SS 1034761 P3 - CEL On and Engine de-rate due to ATD Chassis Harness Circuit 532M5+ at DEF Heater Supply location is shorted

FTL P3 - Cascadia

Circuit 532M5+ Damaged at DEF Heater Line Connector:

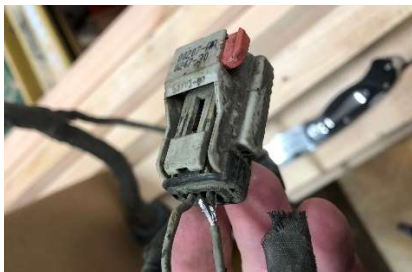
Harness part number A66-03217-002 has been reported experiencing failures due to damages to 532M5+ circuit shorting /or corrosion in terminals at Connector (23-13153-200) harness location "ATD_CHAS_F_O_HTR_LINE_DEF_5B" .

Connector backshell is available to be added at the location indicated to add extra protection to wiring and also reduce or eliminate terminal corrosion.

Required part number: 23-13302-633 -- Backshell
